16910 Thompson
Road, 80908

OWTS Design

Project number 21-017

① 01- Site Plan
1" = 60'-0"

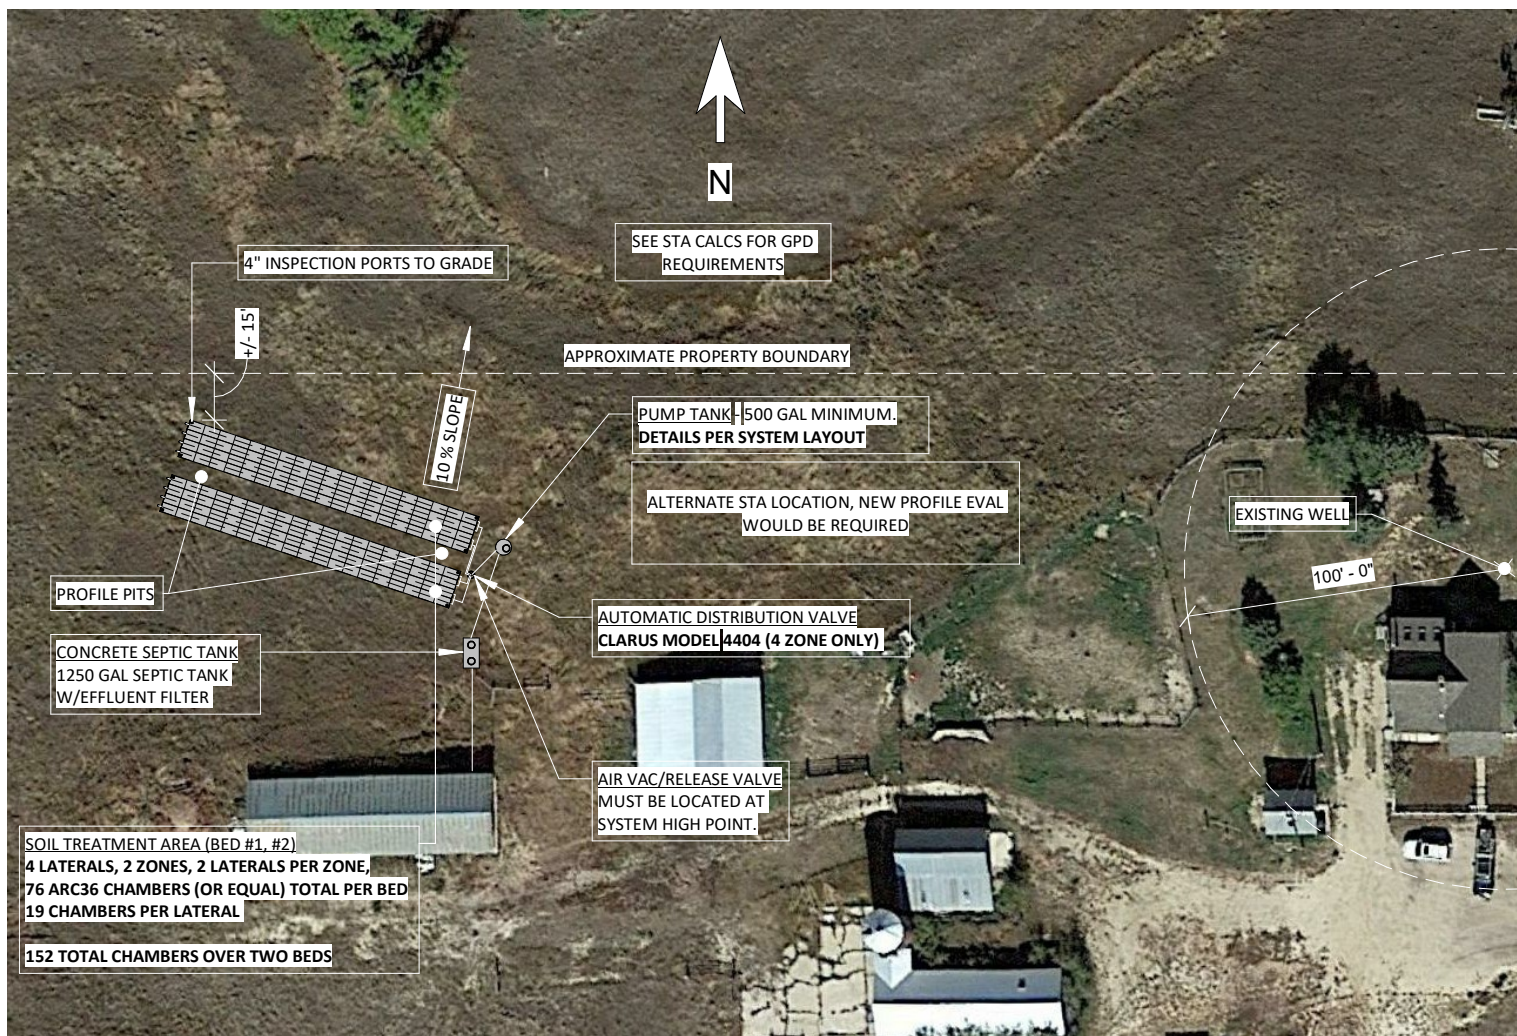
This is an OWTS design - not a septic permit. Please provide a copy of the septic permit.
